# **Taraborah Coal Project**

## **Response to Submissions on the Draft Environmental Impact Statement**

**RE: Response to Submissions on the Draft EIS for the Taraborah Coal Project**

Figure 12 of Appendix 7 has been amended to look as follows:

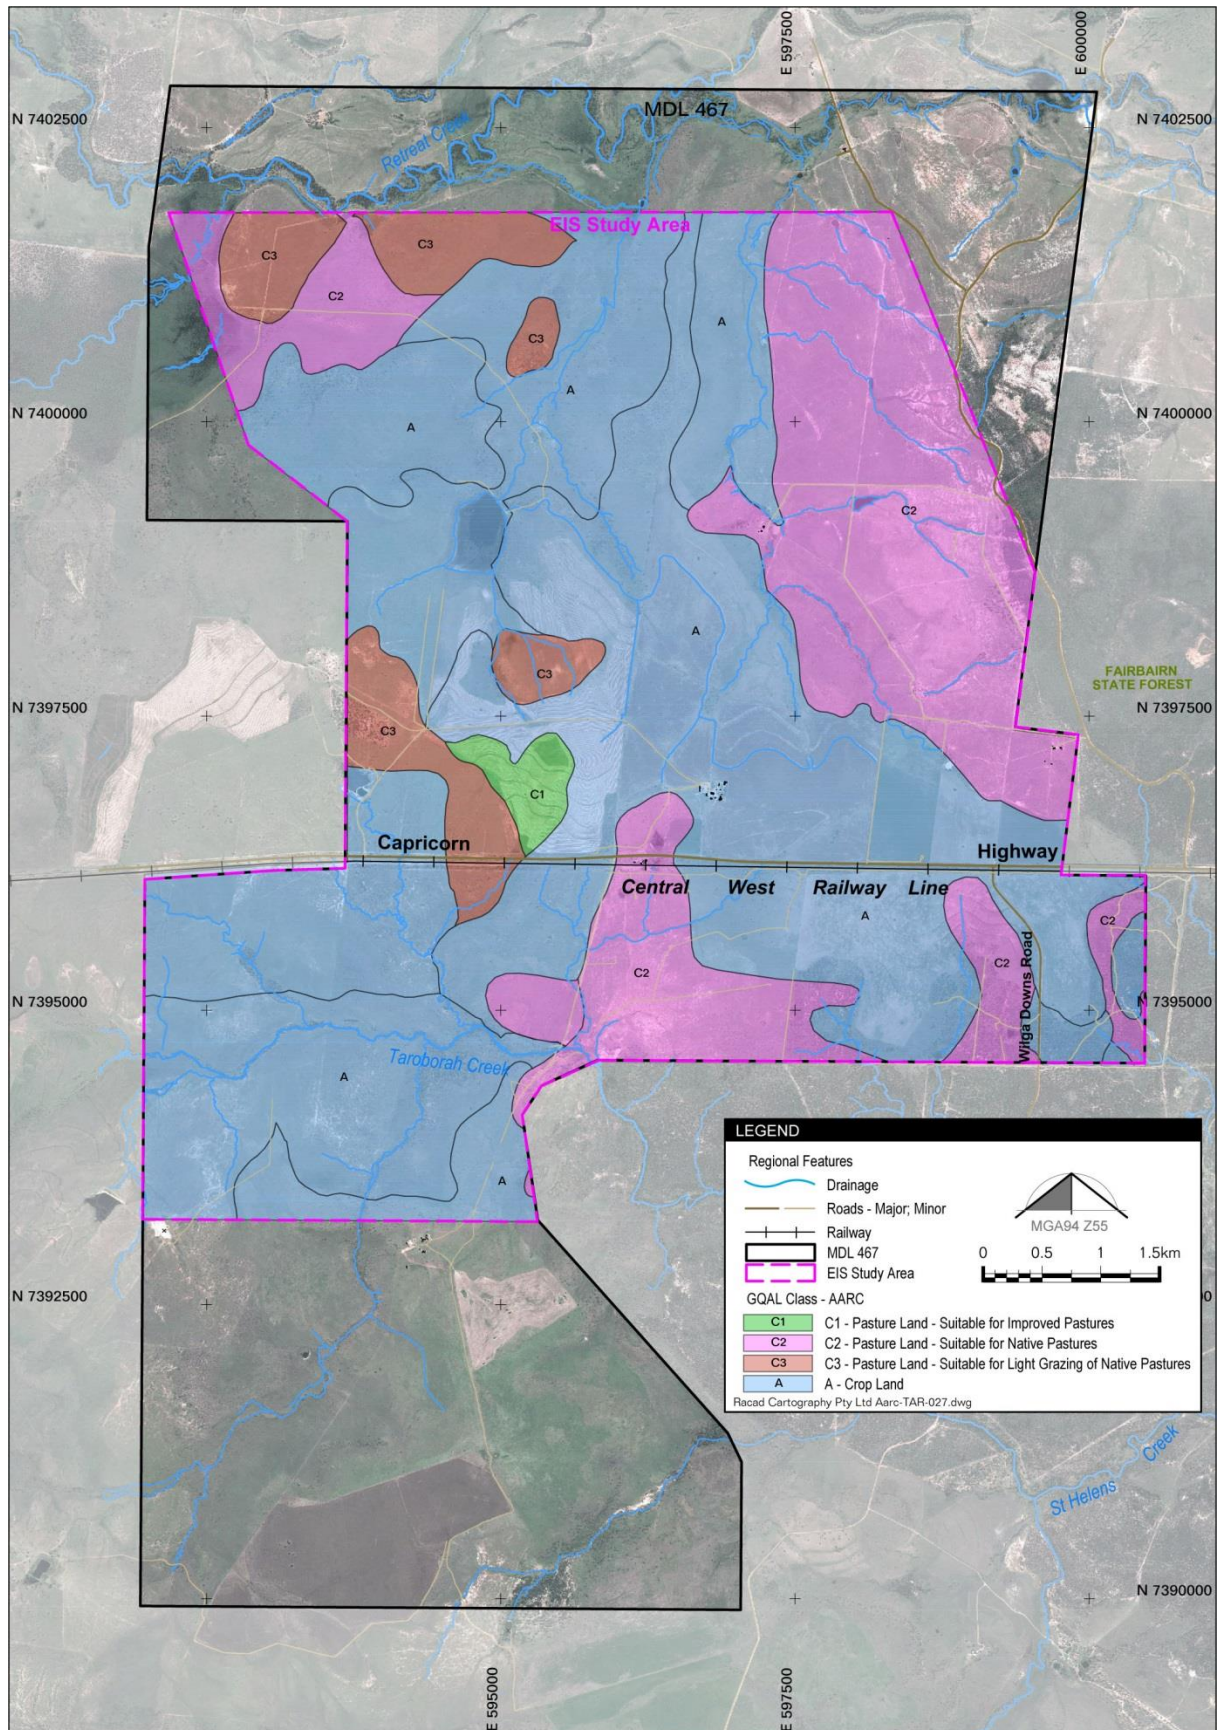
Inadequate mapping intensity and separation of soil units. The Terms of Reference (TOR) Section 4.2.1.5 requires a soil survey mapping intensity of 1:25 000 scale not 1:50 000 scale as conducted. The TOR refer to DME 1995 and McKenzie et al 2008 for the required site intensity. The required site intensity is likely to have provided a more detailed soil map with separation of the units identified at soil type level. The soil map (Figure 8) contains less detail than the broadscale Geological map (Figure 4). Proponent needs to provide justification for the reduced mapping intensity.

**EIS Amendment:**

**Figure 1 : Surface Drainage Direction (N-S) in relation to Longwall Panel Orientation (E-W)**

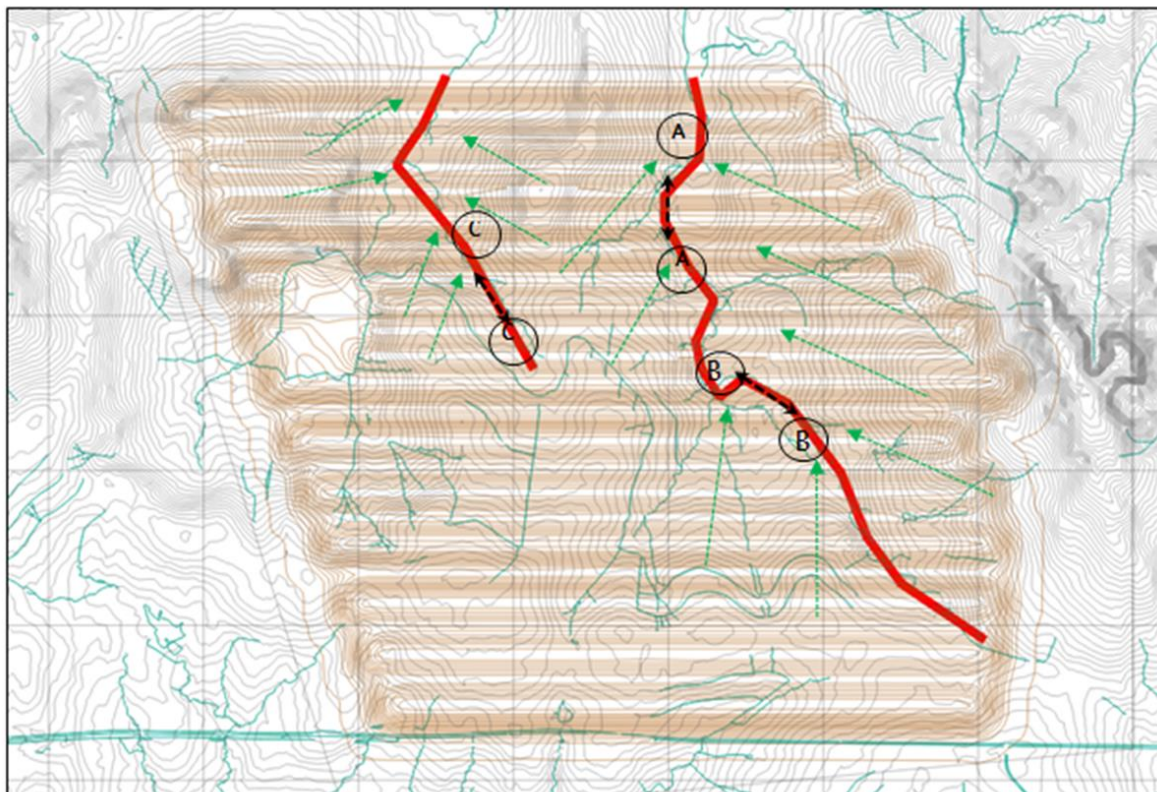
As shown in the figures below, even though the site runoff flows perpendicular to the proposed length of the underlying longwall panels (Figure 1), the subsidence model completed for the project predicts that the changes in grade along the drainage pathways due to subsidence are small when compared with the natural gradients and, therefore, are unlikely to have a significant impact on the surface water flows. Thus, depths of any formed subsidence troughs are predicted to be 1m or less.

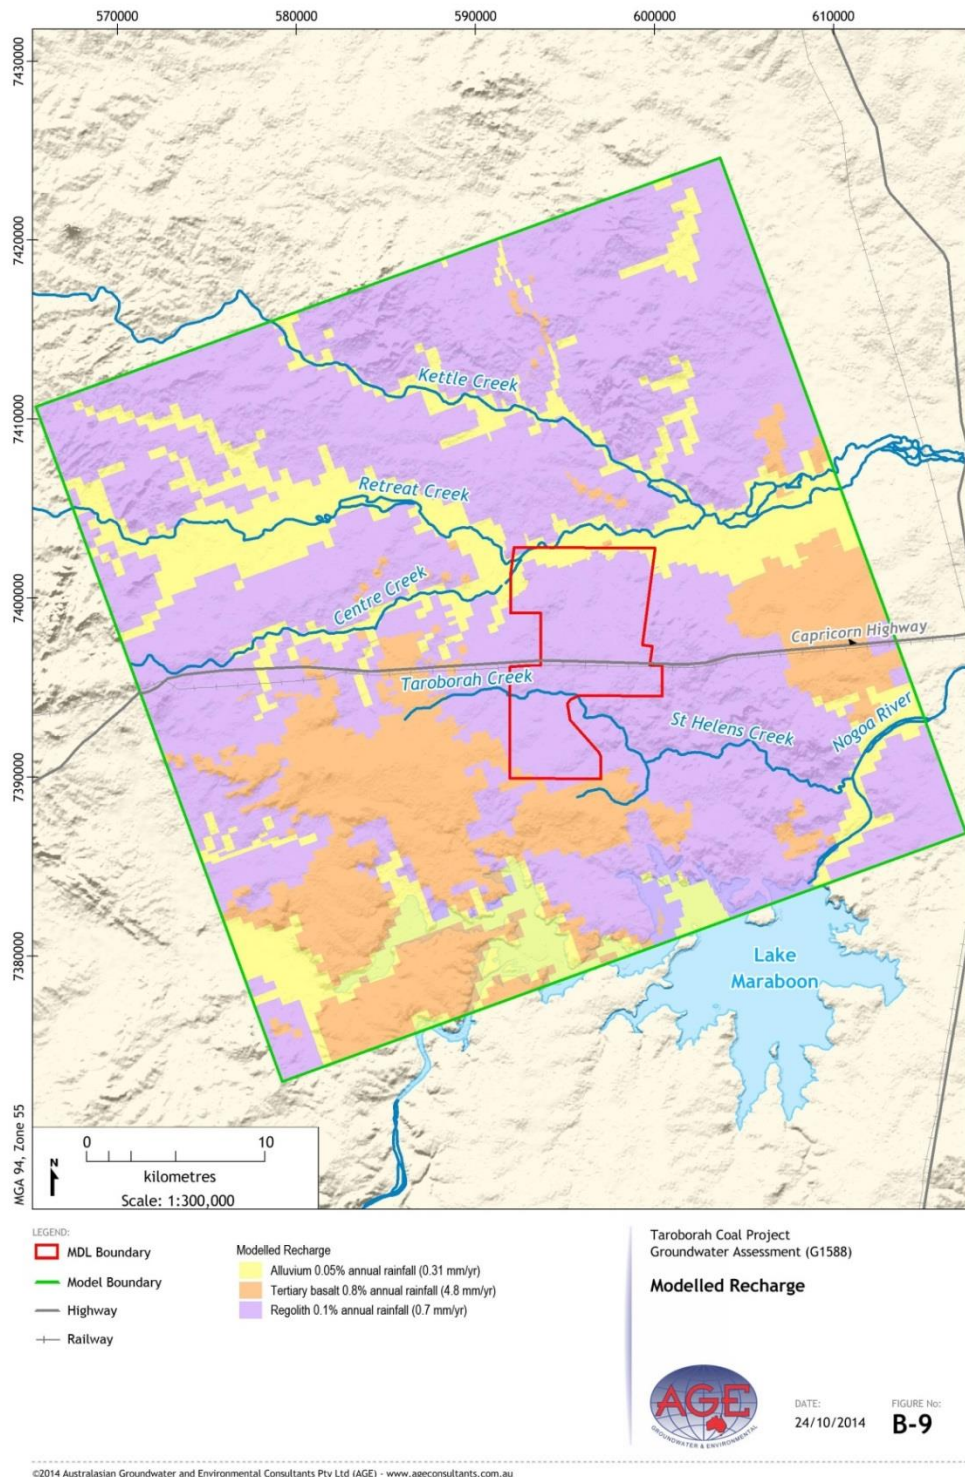
Rainfall recharge was applied across the model domain – as shown in Figure B-9 below. Bore logs to the east indicate the presence of thick sequences of shallow silts and clays overlying the Aldebaran Sandstone that would inhibit recharge, and therefore zones of recharge for the Aldebaran were not applied. Irrespective of this, the sensitivity analysis showed that a decline in recharge had little impact on the predicted extent of drawdowns and mine inflows, and an increase in recharge visibly reduced the extent of impacts. Therefore, the approach used is considered conservative and suitable based on the information available for recharge at the site.

A new Figure B-9 referenced above and included below and illustrating the influence area of the recharge mechanisms has been added to Section 3.3 of Appendix B of EIS Appendix 14.
